SERVICE BULLETIN

NO. B-98

SUBJECT: CYLINDER ASSEMBLY-INSPECTION OF HOLD-DOWN WASHER SPOT FACE AREA

FIGURE I

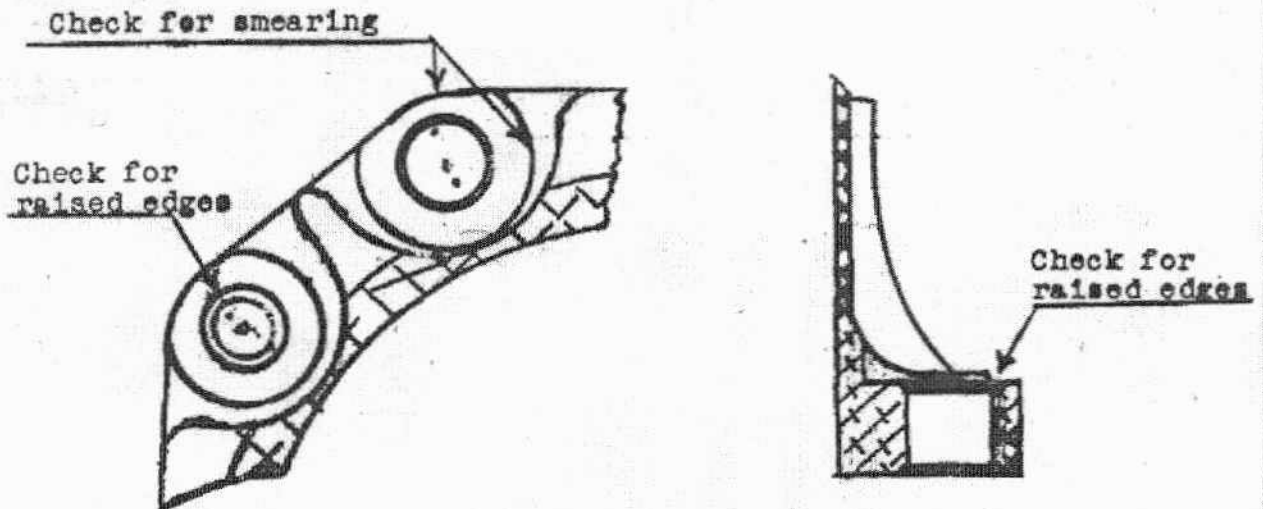
DETAILED INSTRUCTIONS: Inspect all cylinder mounting flanges at the spot faced area for raised edges at the stud holes and smearing at the spot face outside diameter. (See Figure I).

If raised edges are observed around the stud hole, lightly scrap away all raised material with a hand scraper, until the area is flush with the spot faced section.

If smearing is noted at the spot face outside diameter, carefully scrap away the excess with a hand scraper until a cylinder hold-down washer seats perfectly on the spot face.

Care must be used to prevent damage to the spot face fillets if scraping is required.
